ROGERS JOSEPH O'DONNELL

Re: Initial Comments of Chevron U.S.A. Inc. – Petition of Zief Foundation, Proposed Order Directing Reopening of Underground Storage Tank (UST) Case and Further Corrective Action at Former Chevron Service Station Located at 2009 South El Camino Real, San Mateo, Case No. 9-7863 dated February 20, 2014 – April 1, 2014 Board Meeting

STORMWATER COLLECTION AND CONVEYANCE SYSTEM REPLACEMENT DESIGN PLANS

20 East 20th Avenue, San Mateo, California

STORM WATER CATCH BASIN		DWG # T2
PROJ. MAN. DOUG P.	DWN. PAUL C.	
DATE: JAN. 23, 06	MODEL: MFCB10-421B-48665-4WH

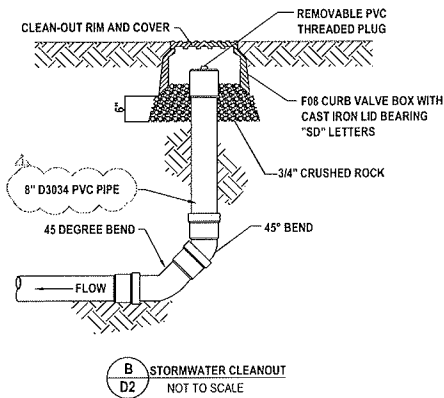
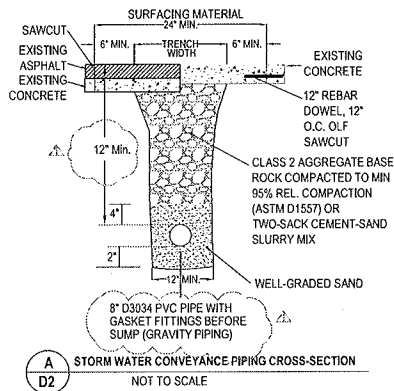
3. **Catch Basin:** The plans showed catch basin with weep holes. Concern that this is counter to the objective of sealing the system from groundwater.
